UNITED STATES PATENT AND TRADEMARK OFFICE

APPLICATION NO.	FILING DATE	FIRST NAMED INVENTOR	ATTORNEY DOCKET NO.	CONFIRMATION NO.
10/779,502	02/13/2004	Andrew G. Gilicinski	08935-300001	1646
26161 7590 04/09/2007 FISH & RICHARDSON PC P.O. BOX 1022 MINNEAPOLIS, MN 55440-1022			EXAMINER ALEJANDRO, RAYMOND	
			ART UNIT	PAPER NUMBER
			1745	
SHORTENED STATUTORY PERIOD OF RESPONSE		MAIL DATE	DELIVERY MODE	
3 MONTHS		04/09/2007	PAPER

Office Action Summary

DETAILED ACTION

FIG. 1

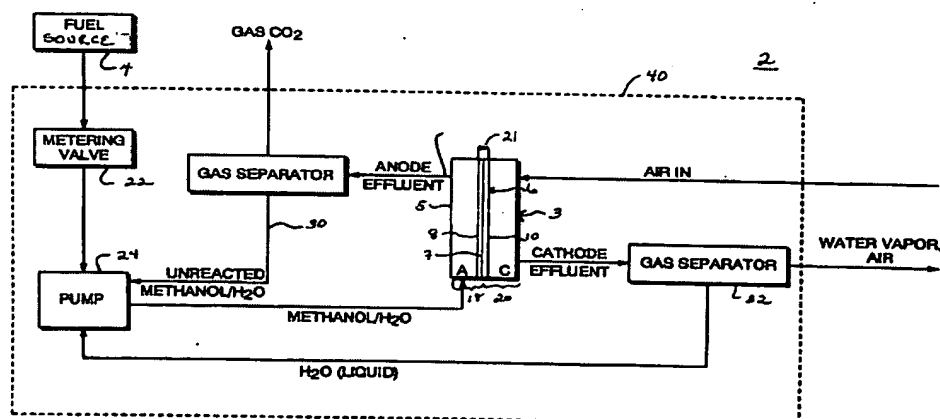
Figure 1 of Hirsch illustrates a fuel cell system 2 including a direct methanol fuel cell 3 (DMFC) (P0030); a methanol fuel delivery source 4 (P0030, 0032) and a pump 24 (the gas mover) assisting in the circulation of fuel and positioned between the fuel cell 3 and the fuel delivery source 4 (See FIGURE 1 & P0032-0033).

Fuel delivery source 4 is designed to enclose/hold and to supply the methanol (P0030, 0032). *Thus, it comprises a housing.* Figure 1 depicts its outlet (See FIGURE 1); and the pump 24 (the gas mover) is positioned between the fuel cell 3 and the fuel delivery source 4 (See FIGURE 1 & P0032-0033).

Disclosed therein is that un-reacted methanol and water is separated from carbon dioxide in separator 30 and re-circulated to the pump 24 (P0033). *Thus, in this case, gas separator 30 separating un-reacted methanol and water from carbon dioxide is taken to also represent a fuel source (because it is supplying un-reacted methanol), and in combination with the recirculation loop provide the necessary arrangement to have the pump 24 between the fuel source inlet and the fuel cell after a first recirculation loop cycle is completed.*

In the absence of a specific structural description of a diffusion tube, it is contended that the pipe supplying methanol/H₂O to the fuel cell (See FIGURE 1) can be considered to be a diffusion/distribution tube.

Metering valve 22 is placed between the fuel cell 3 and the fuel delivery source 4 (See FIGURE 1).
